**CENTER FOR DRUG EVALUATION AND  
RESEARCH**

**201820Orig1s000**

**OTHER REVIEW(S)**

## NDA 201-820 – Regulatory Device Consult

**Figure 2: Breathing Gas Path Components of PARI LC Plus Nebulizer**

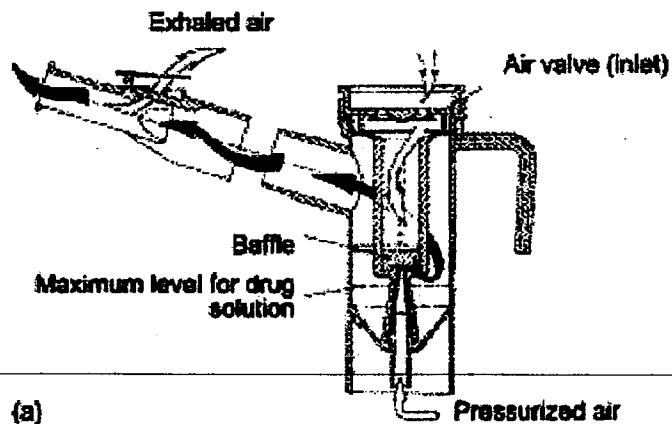
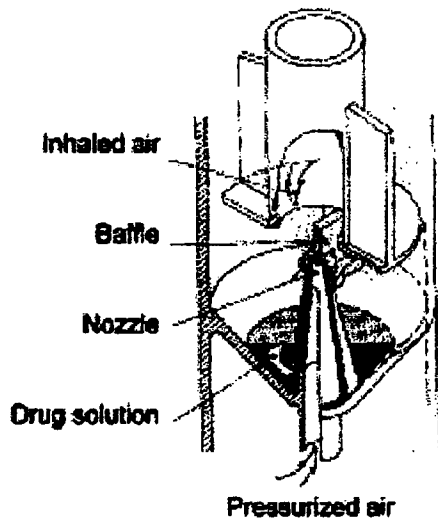
The information provided for review illustrates the gas path of the nebulizer and demonstrates that no adulterations or modifications have been made to the 510(k) approved device design. The Instructions for Use for the device are not affected by the proposed configuration.

**Figure 2: Breathing Gas Path Components of PARI LC Plus Nebulizer**

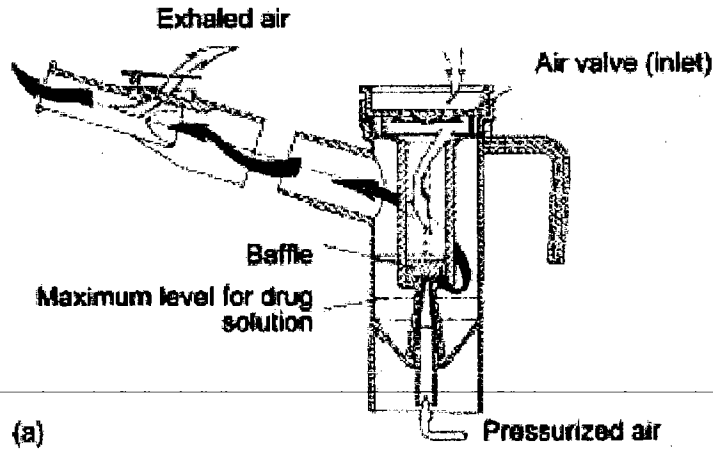
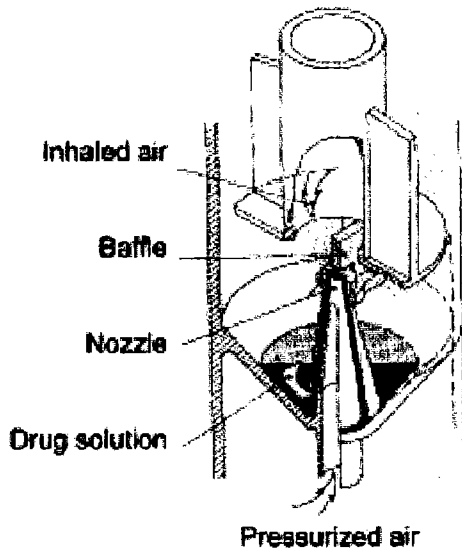
The information provided for review illustrates the gas path of the nebulizer and demonstrates that no adulterations or modifications have been made to the 510(k) approved device design. The Instructions for Use for the device are not affected by the proposed configuration.
